# ATTACHMENT 2 - RESUBMITTAL

## COMMENT RESPONSE LETTER

NEW RIVERSIDE - STORE # 1062  
SC HIGHWAY 46 & E PARKSIDE COMMONS  
BLUFFTON, SOUTH CAROLINA

CAR WASH AND DUMPSTER ENCLOSURE ELEVATIONS

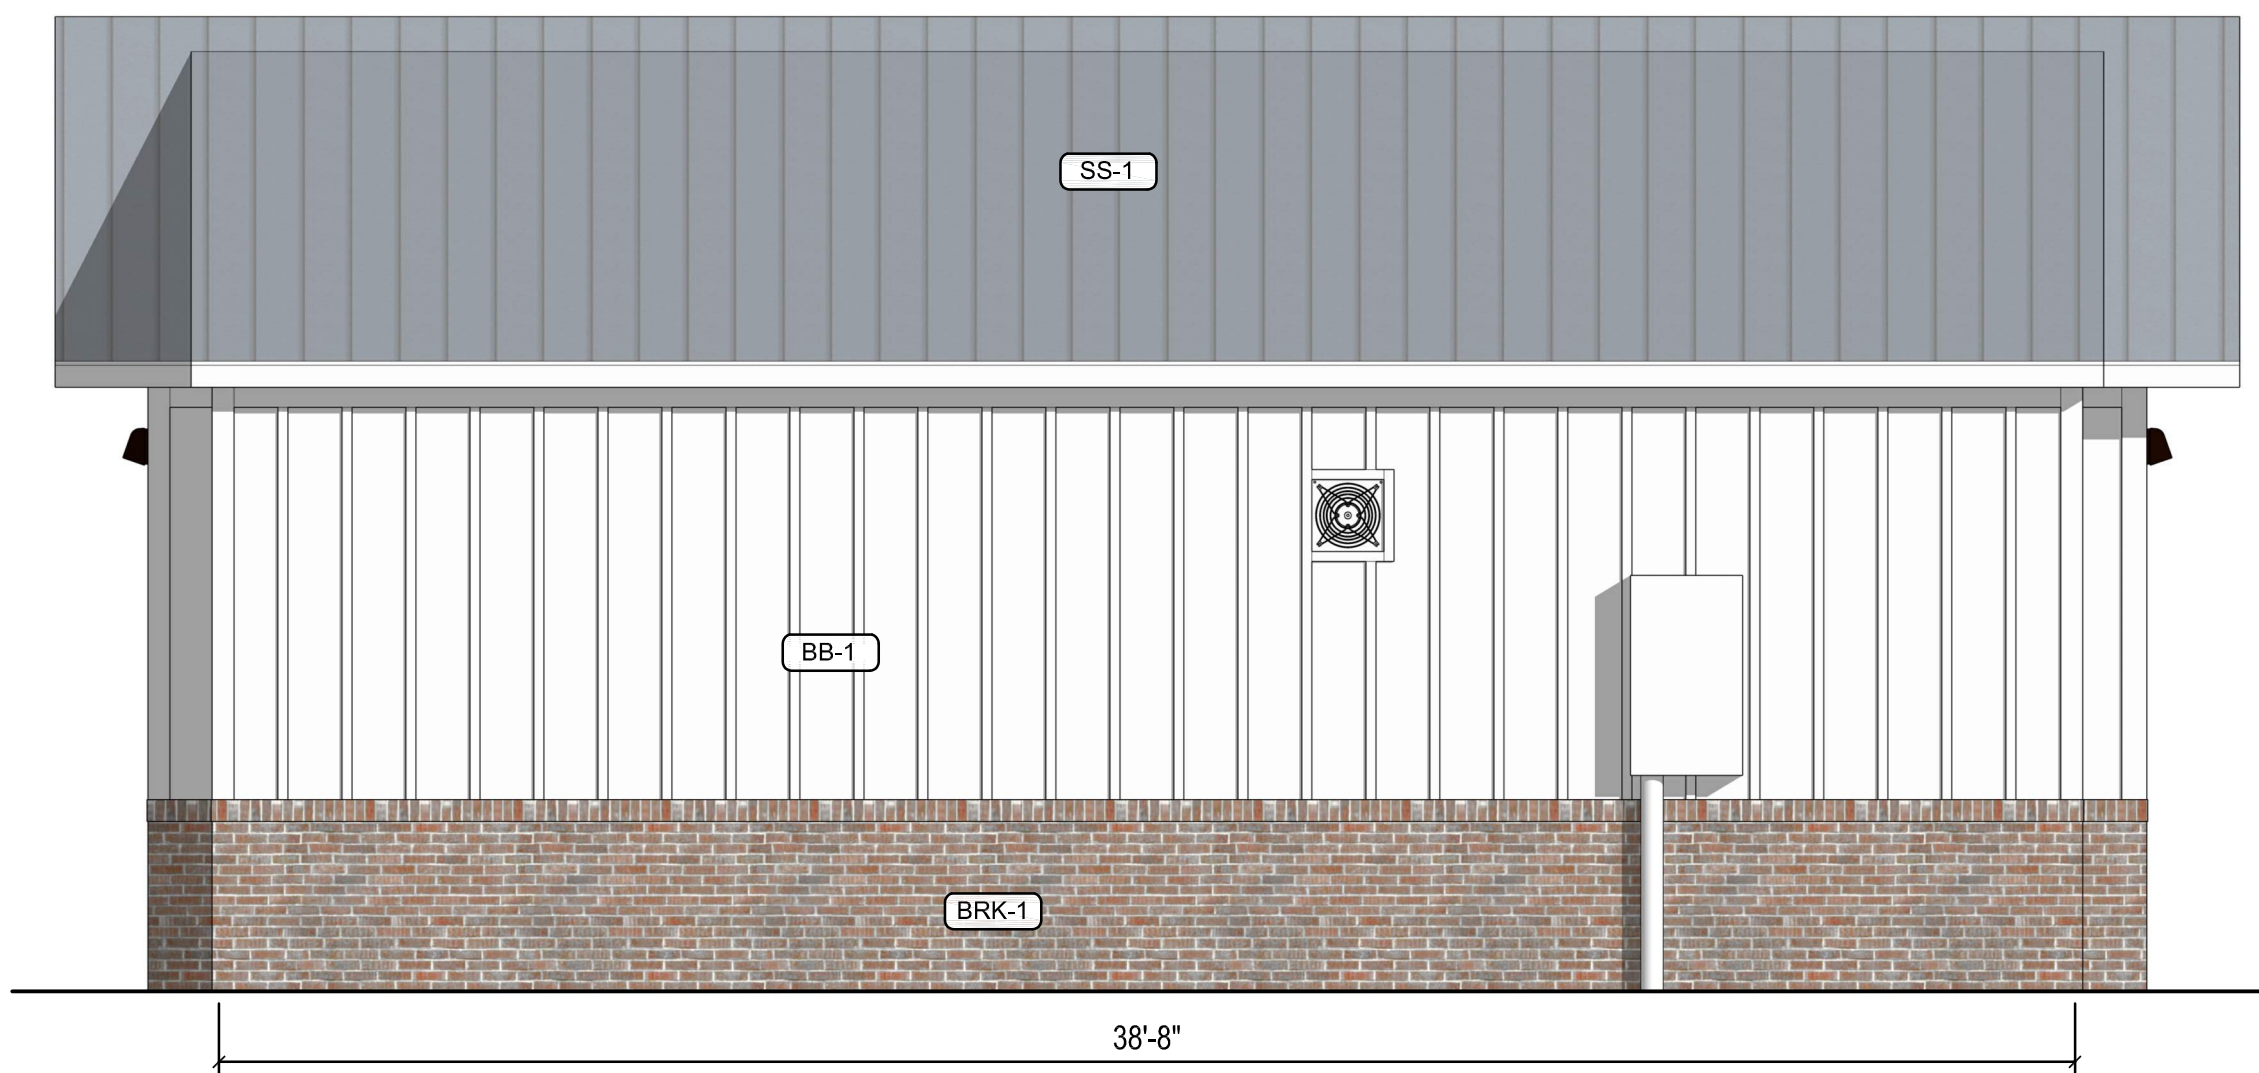
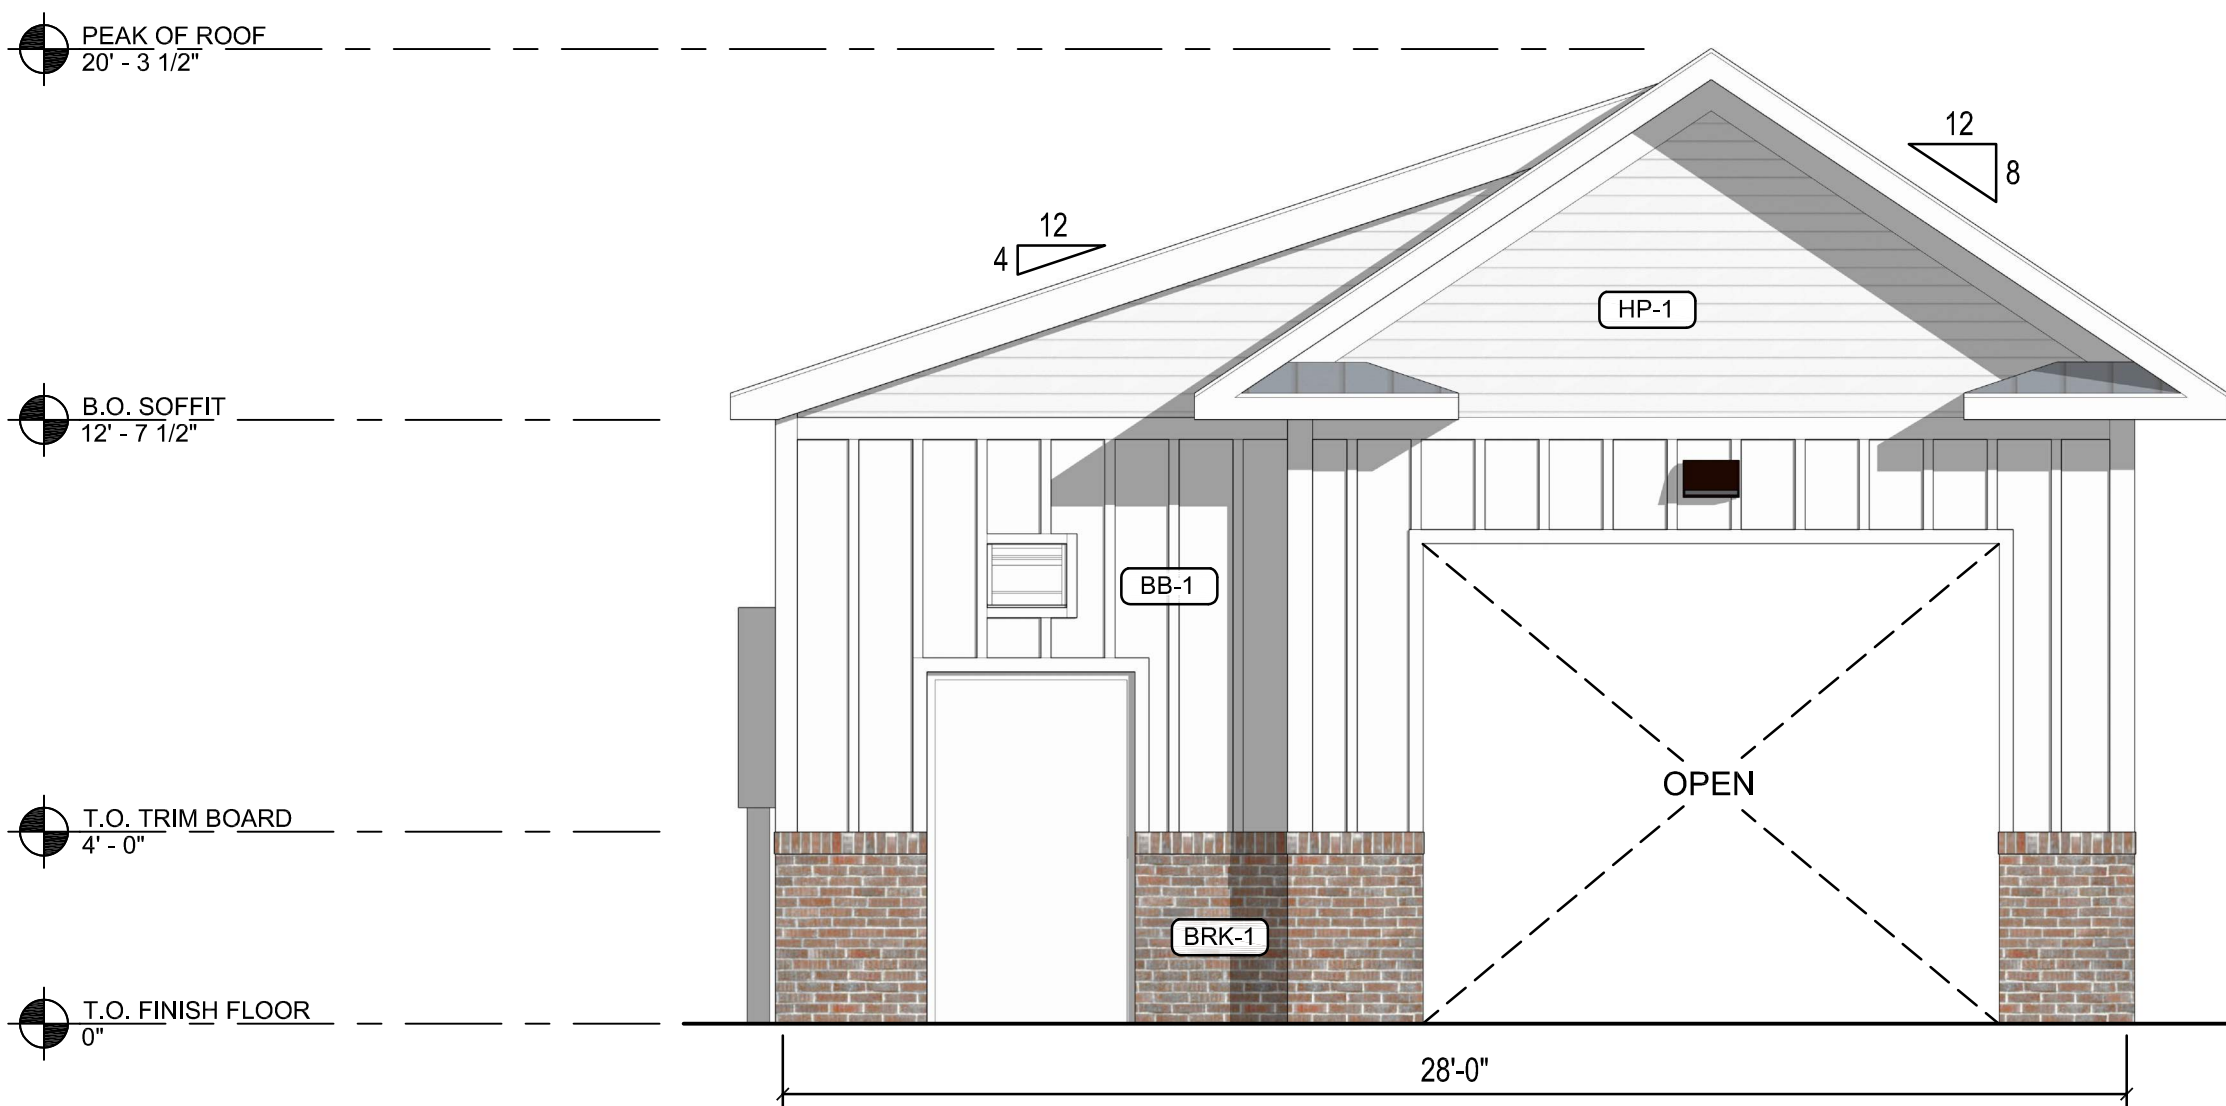
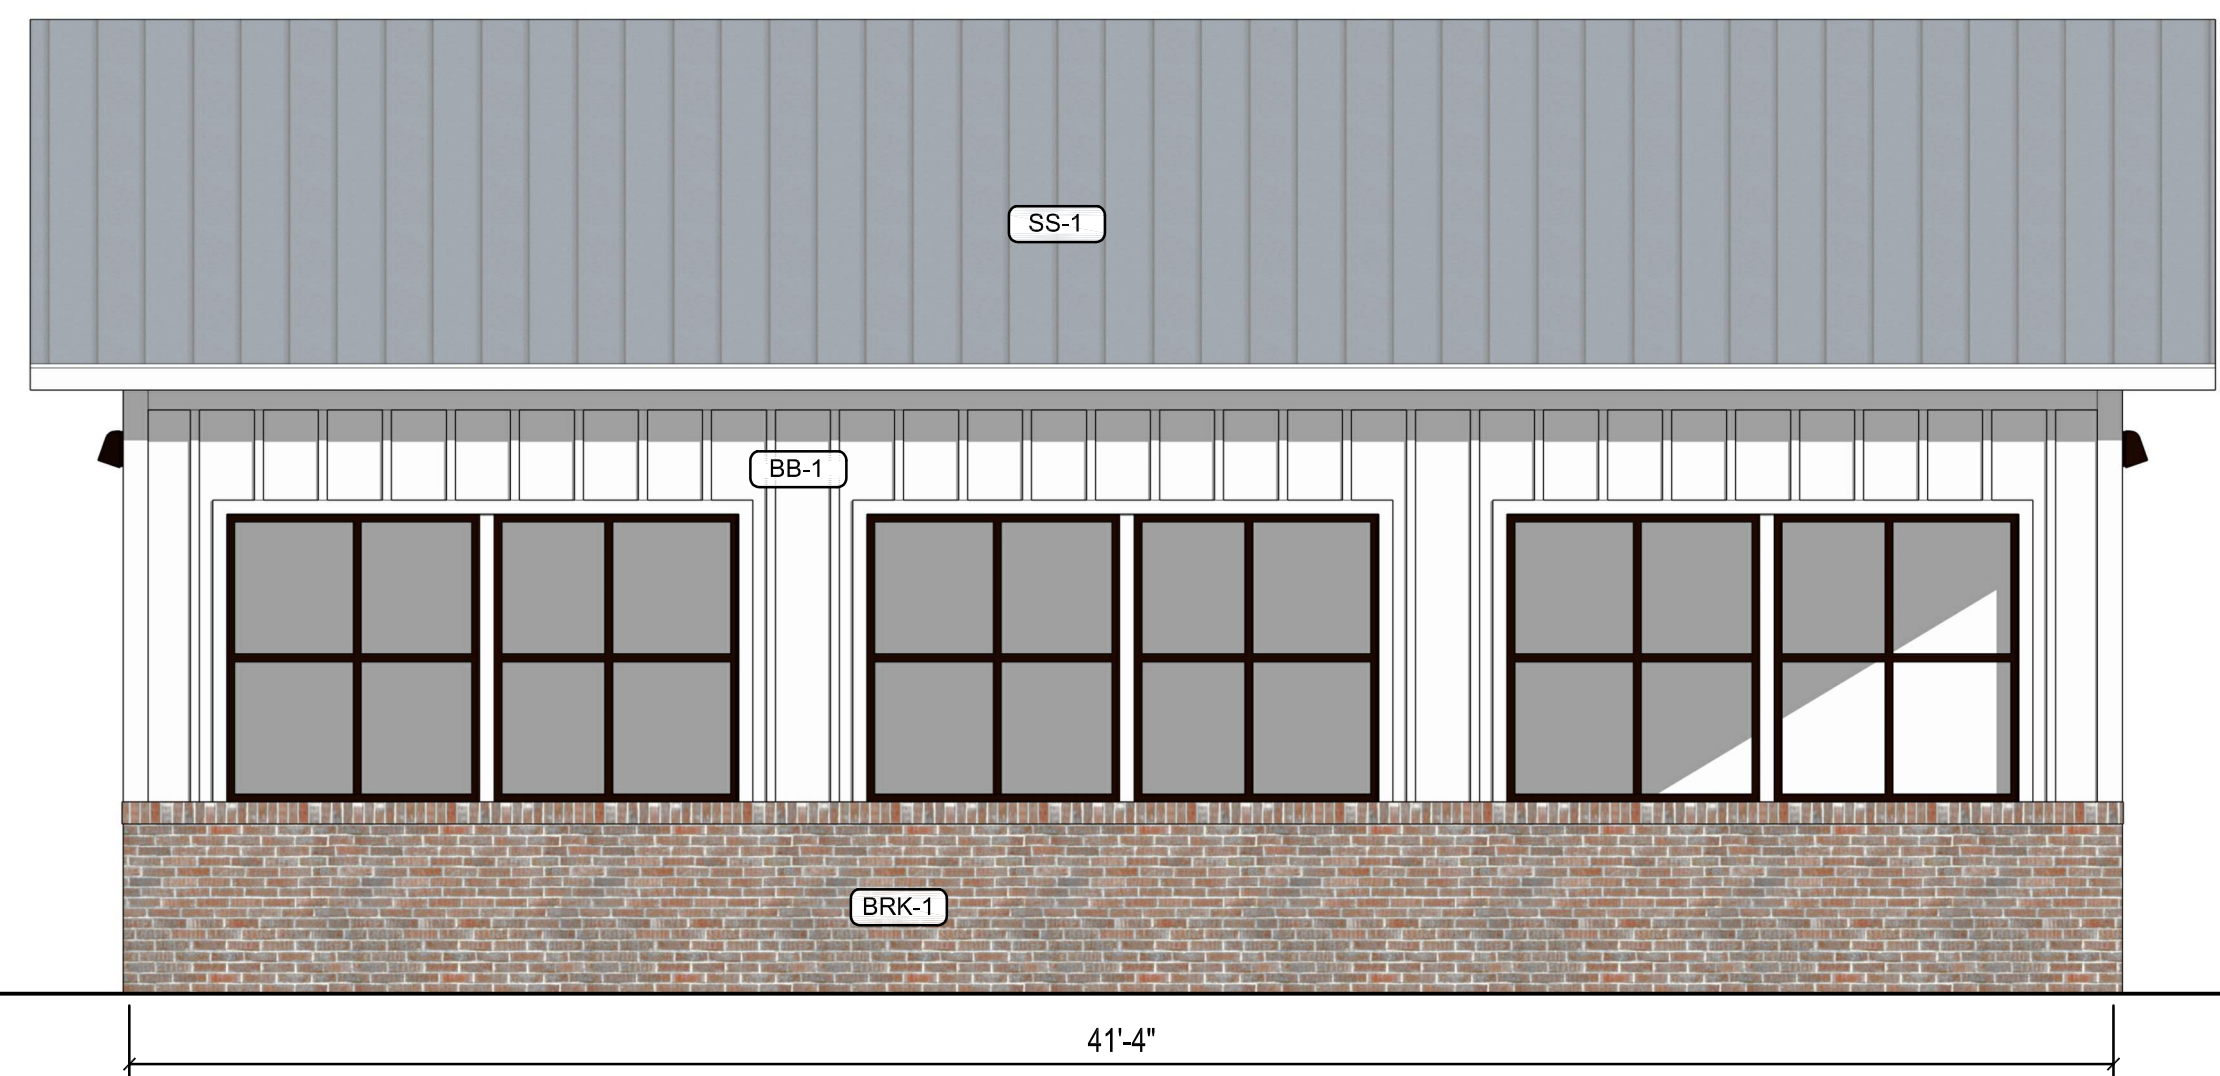
- b. Per Section 5.15.9.(D)(2), the 2 and 12 pitched roof must be revised to a minimum of 4 and 12.

Response: Car wash roof has been modified to comply with 4:12 minimum.
